Parts & Accessories Bulletin

P&A #350

XL SHIFTER CAM 34012-75B

Gear Shifter Cam

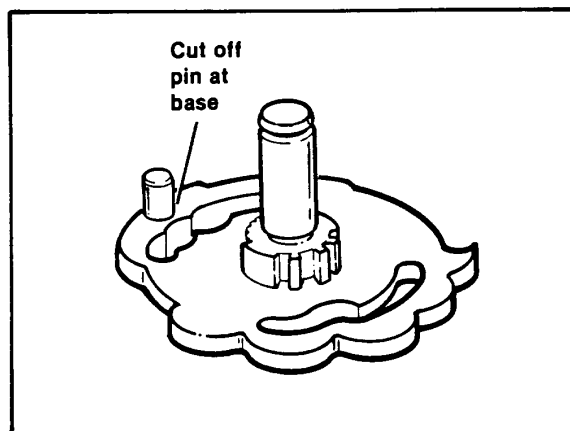
It has come to our attention that shifter cam Part # 34012-75B will interfere with the crankcases when installed in 1975 or 1976 XL transmissions. See illustration. To avoid this interference the .375 diameter pin which is welded perpendicular to the plate, near the outside edge, must be cut off flush with plate
